REVISION
REV A 29.9.24
- LIFT 1 & ASSOCIATED LANDINGS PROPOSED FOR DELETION

PROJECT	Proposed modification of DA2020/0776 - deletion of Lift 1 at 16 Cabarita Rd, Avalon
DRAWING	Cover Sheet

DRAWN SD	CHECKED PD
SCALE 1 : 100	DATE 19.3.20
DRG. A2 2003 01A

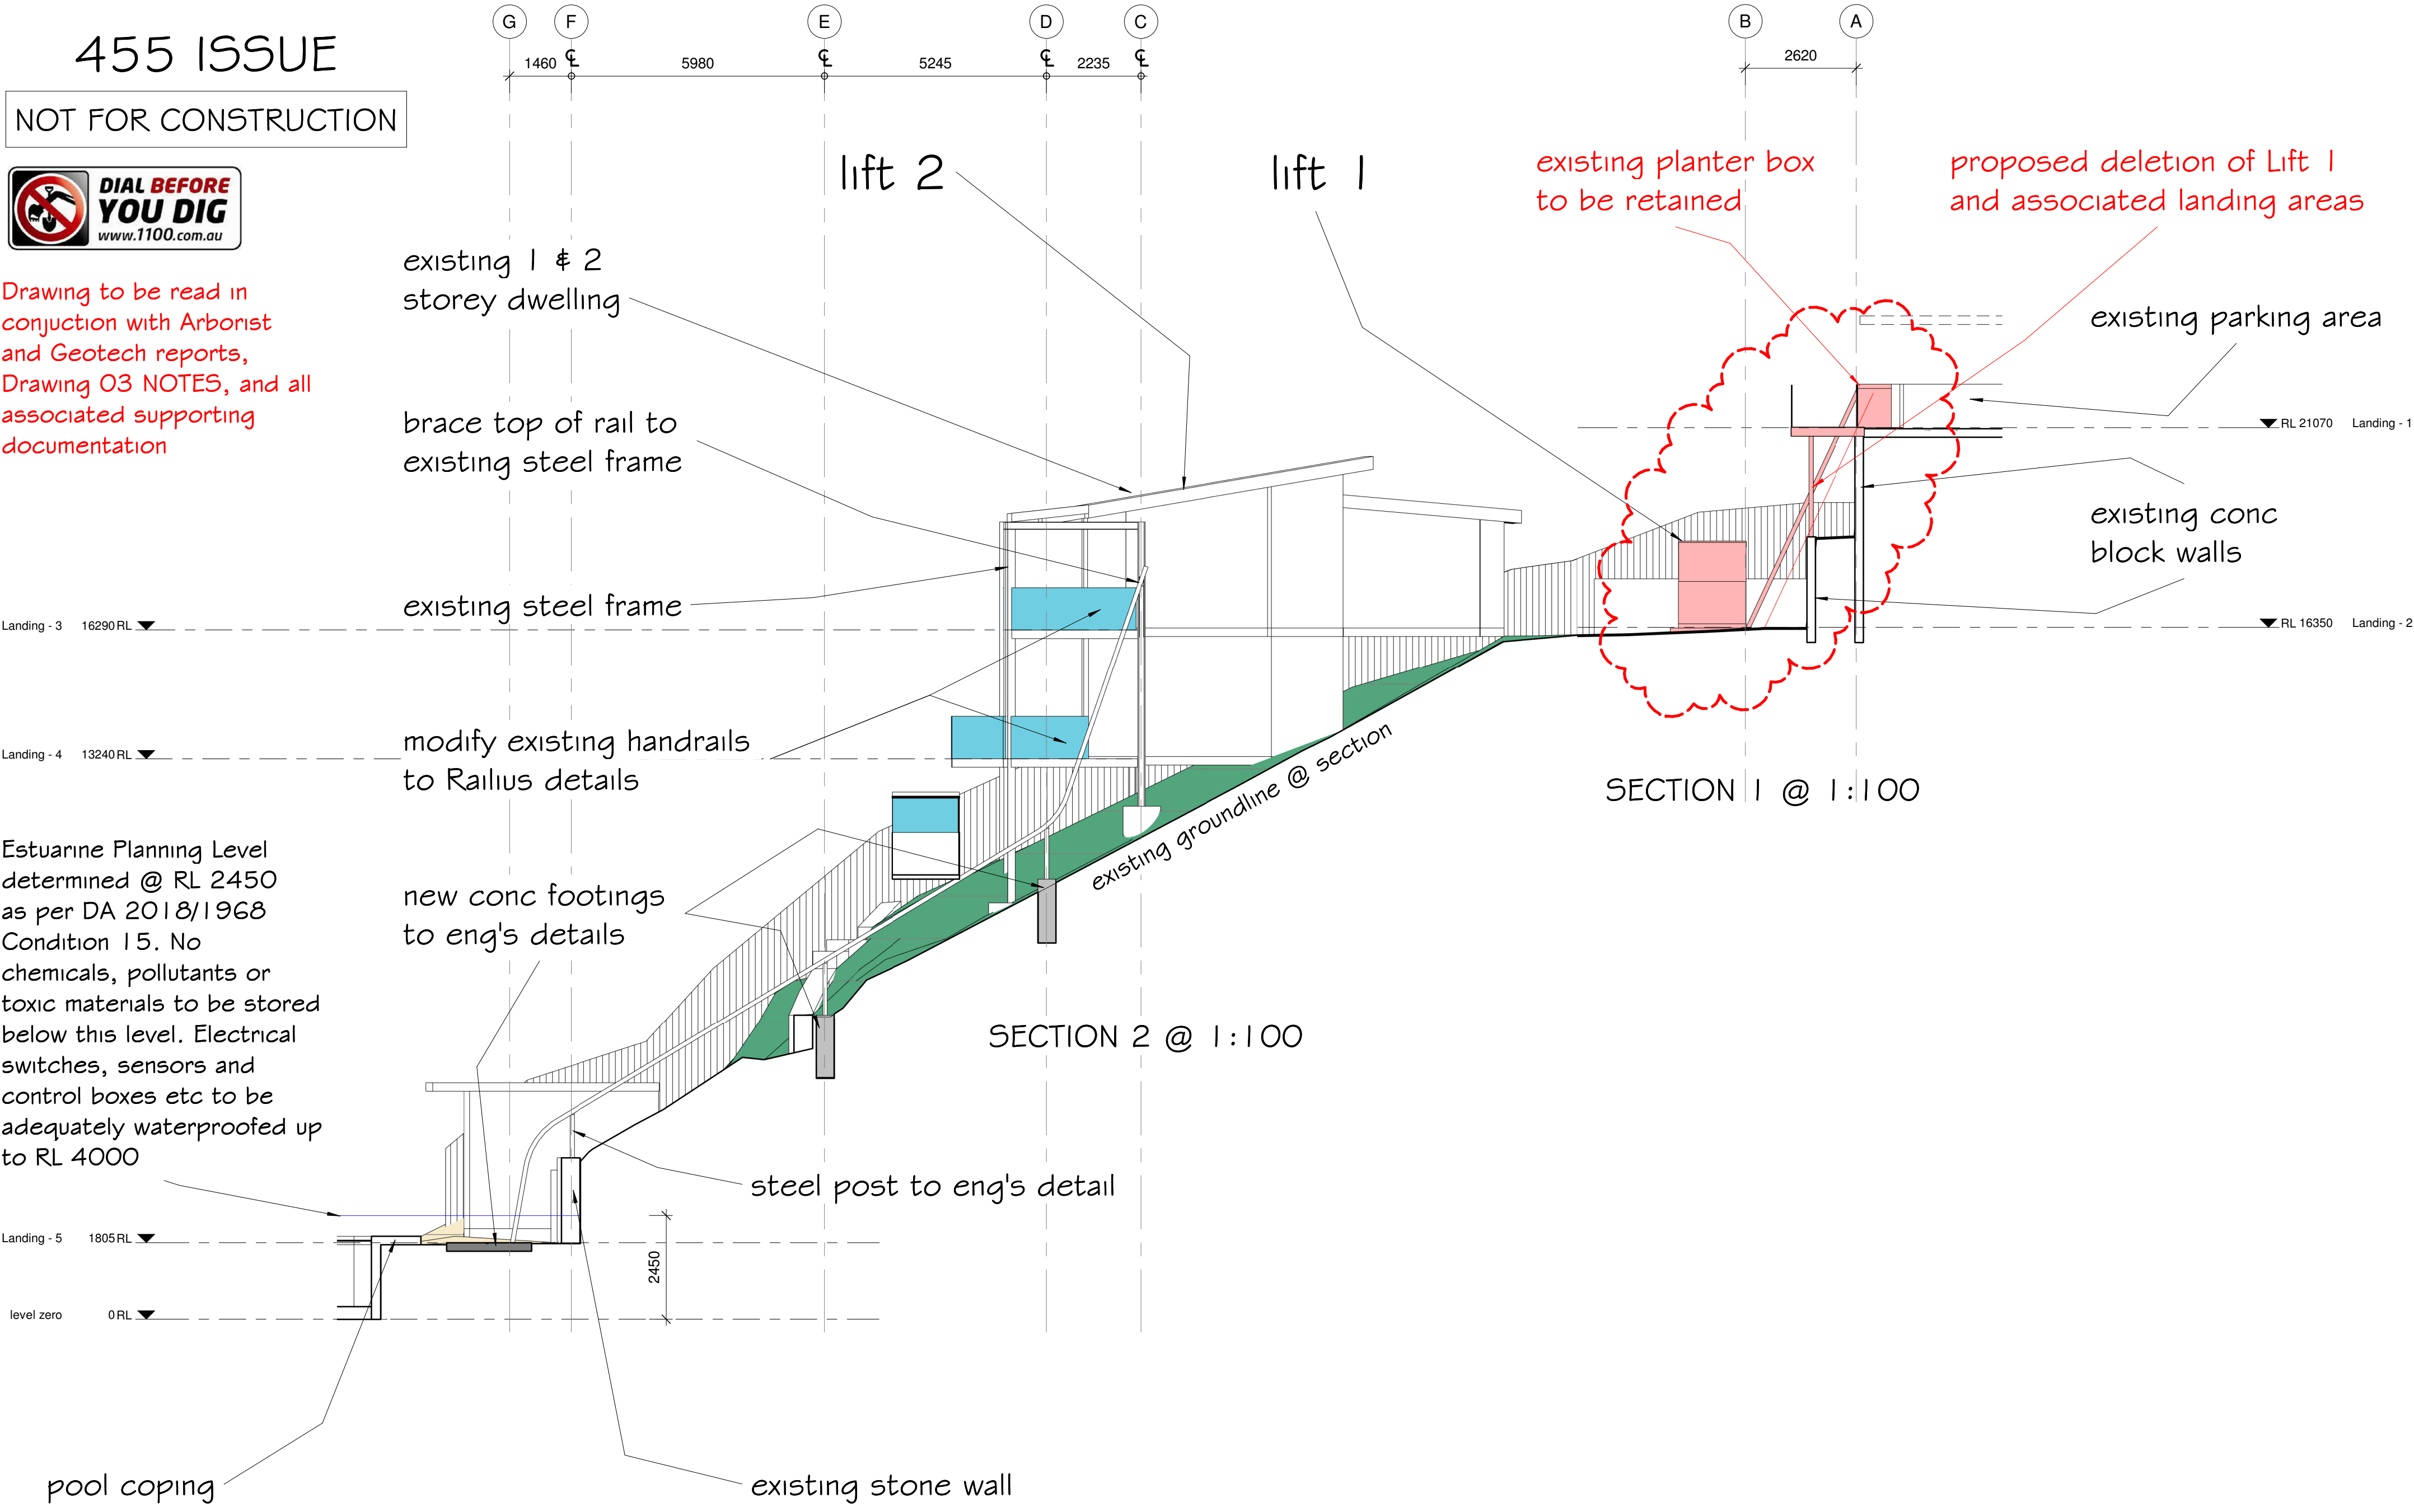
proposed deletion of Lift 1
and associated landing areas

REVISION
REV A 29.9.24
- LIFT 1 &
ASSOCIATED
LANDINGS
PROPOSED FOR
DELETION
